Date	4/20/10	80-KLB-001r1
Attention	Will Smith	
Regarding	I-90 Hyak to Snowshed Vicinity	
Contract No.	7852	
F.A.P. No.	State Project

COPIES	DATE	NUMBER	DESCRIPTION
			KLB Construction - Revision to Blasting Plan Submittal *ADD# 1 – to Blast Plan FOR APPROVAL

ADDENDUM #1 TO BLAST PLAN

Typical 5" Diameter Production Blast Bore Hole

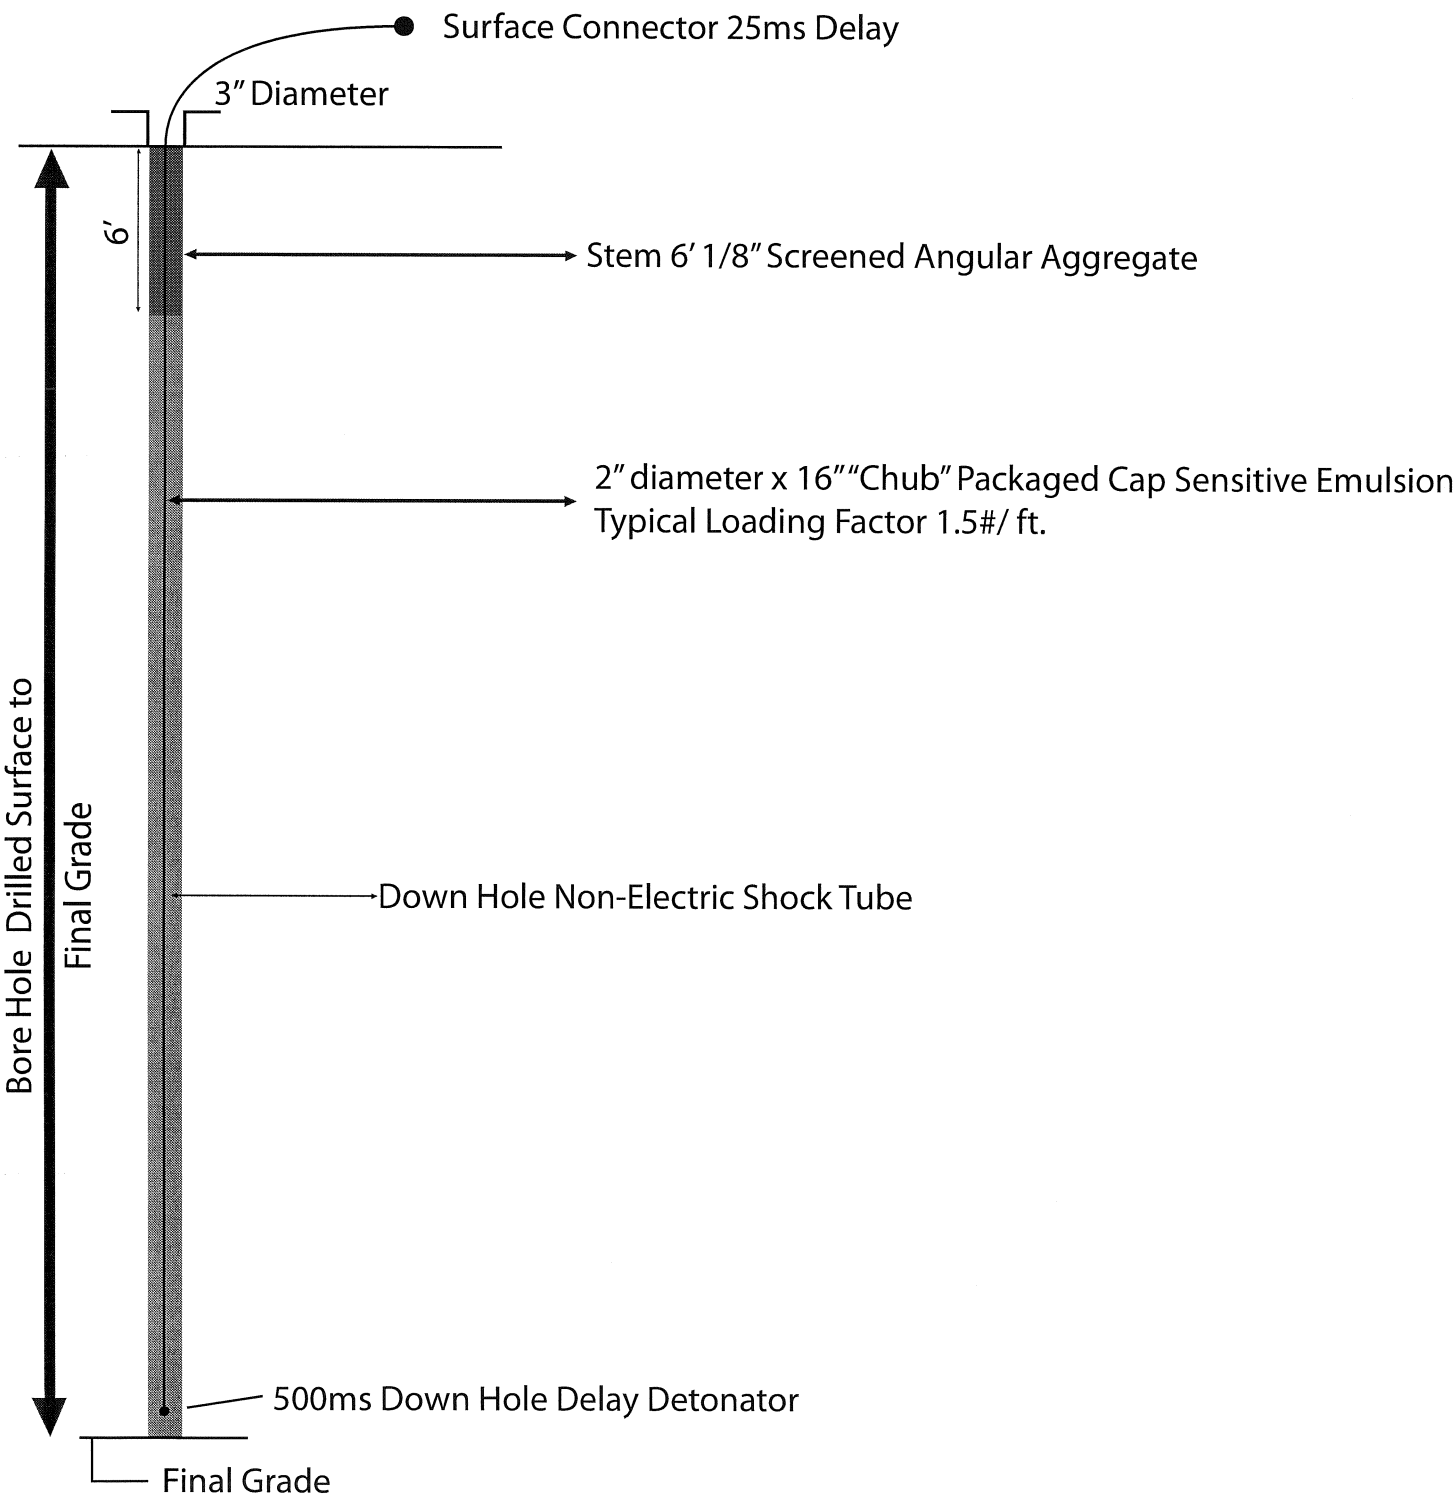
We found a labeling error on one page. The 5 inch hole should have been labeled production hole and not trim hole. We have made the correction on these attached forms. I hope this hasn't caused any inconvenience.
